CONSTRUCTION DOCUMENTS

GARAGE

1318N NEVADA AVE
COLORADO SPRINGS, CO 80903

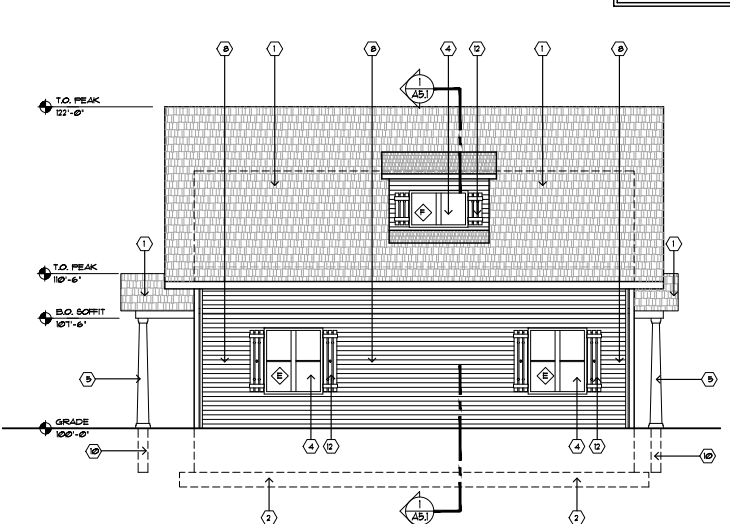
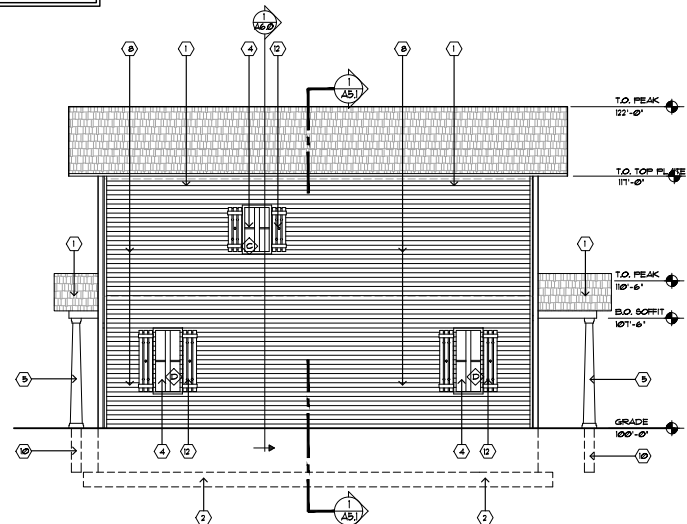
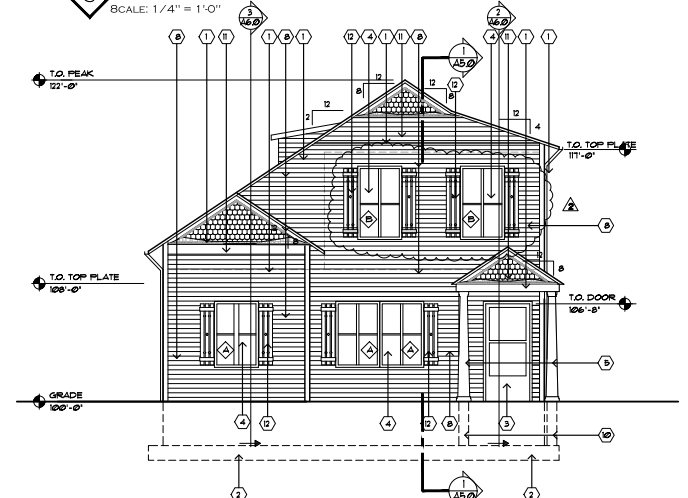
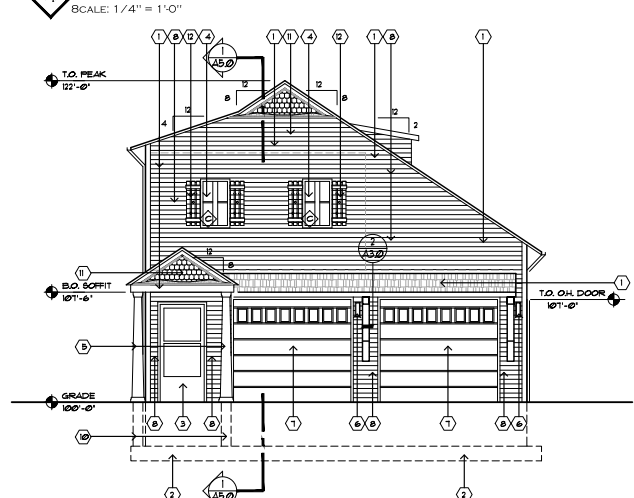
Provide gutters & downspouts with minimum discharge 3'-0" from foundation
